SITE A: # 3025493: 5256 Rainier Ave S
SITE B: # 3025781: 5217 42nd Ave S

Recommendation Review (REC) Packet, Southeast Design Review Board on
JANUARY 23, 2018

APPLICANT TEAM:
Architect: Johnston Architects PLLC
Landscape: Berger Partnership
Developer: PSW Real Estate

SITE A - NORTH ELEVATION

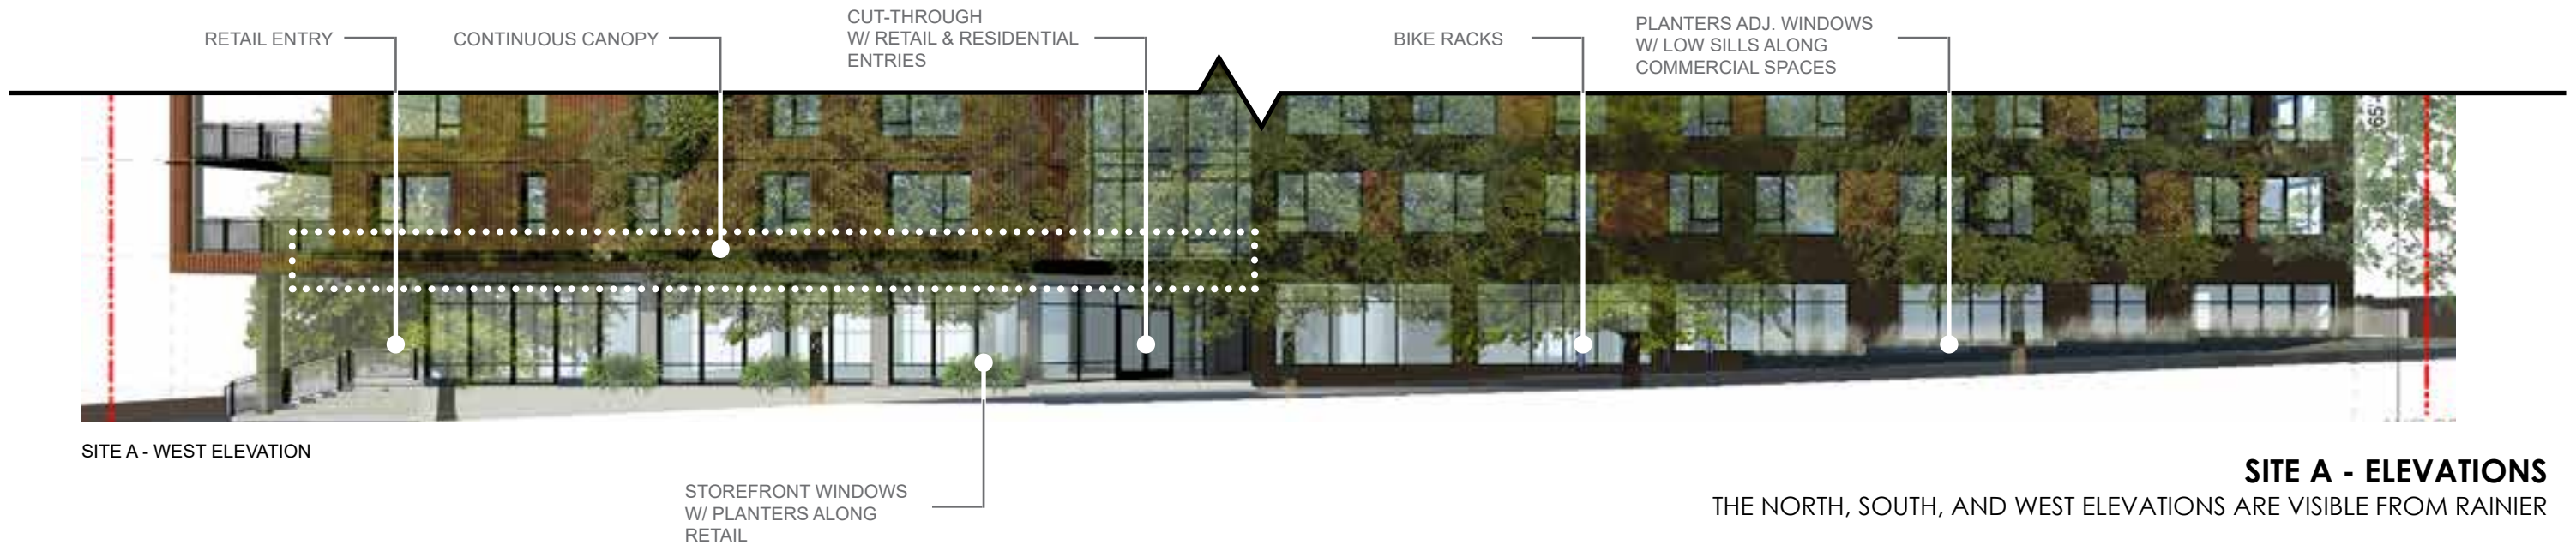
BOARD GUIDANCE 2e. The Board agreed the ground level uses along Rainier do not need access doors directly onto the sidewalk, but recommended the entire street edge have low sills, continuous weather canopies and other features that engage and activate the adjacent sidewalk. The Board agreed this location should reinforce a connection to the commercial core of Columbia City, and provide similar pedestrian features, even if the adjacent uses are not retail. (PL2-C)

PROJECT RESPONSE: The ground-level is highly transparent along the full street facade adjacent to the sidewalk. A continuous weather canopy is provided from the north corner to the Cut-Through. After that point, the sidewalk slopes up, which would make a continuous level canopy awkward; priority was given to keeping the large ground-level windows unobstructed. Other pedestrian-scale elements on the sidewalk include bike racks just south of the Cut-Through, and planters along the building facade at ground-level.

PERFORATED METAL STAIR (TYP.) OVER LOWER LEVEL UNIT PATIOS

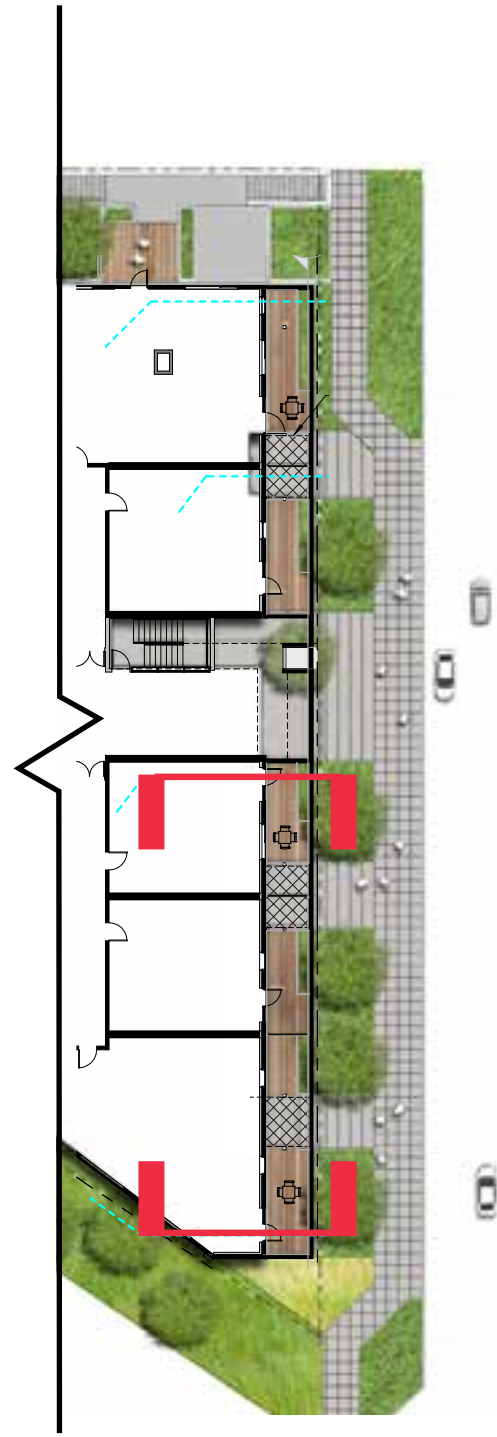
BOARD GUIDANCE 3f. The Board supported the exploration of 2-story townhouse units along this street edge, with living rooms providing eyes on the sidewalk, and sleeping rooms in the darker, sunken portions. (PL3-B)

PROJECT RESPONSE: The shared stoops have been developed, and the stairs are proposed as a perforated metal to allow light penetration into the space below.

PROJECT RESPONSE: All units at Level 2 provide eyes on the sidewalk. The 2-story townhouse units are arranged to have living spaces at Level 2 and sleeping rooms at Level 1. Multiple stoops and the primary entry stairs invite activity at the street edge.

SITE B - PERSPECTIVE OF MAIN ENTRY
STANDING ON SIDEWALK LOOKING WEST AT ENTRY STAIRS & ADA RAMP

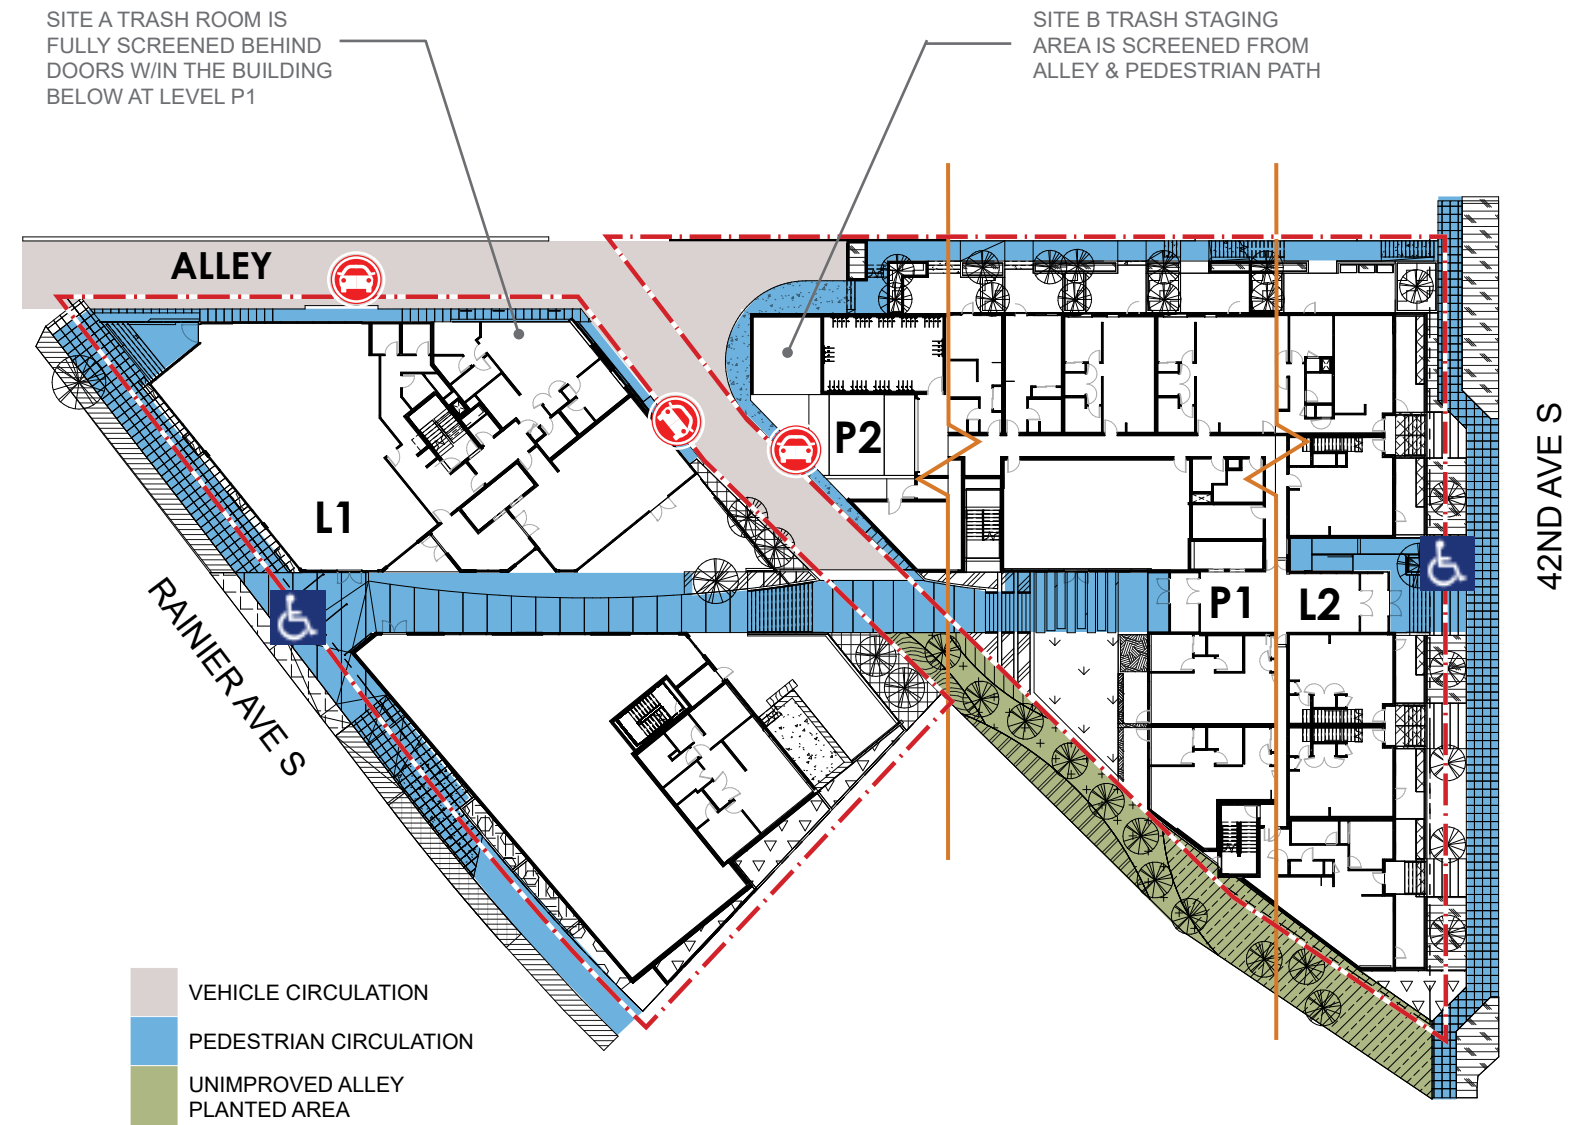
PL2-A-1. Access for All: Provide access for people of all abilities in a manner that is fully integrated into the project design. Design entries and other primary access points such that all visitors can be greeted and welcomed through the front door.

PROJECT RESPONSE: On Site A, the paving of the Cut-Through is designed to meet the grade of the sidewalk, so that no ramping or steps are necessary, and it is accessible for all. An accessible ramp is integrated into the main entry design of the 42nd street facade of Building B.
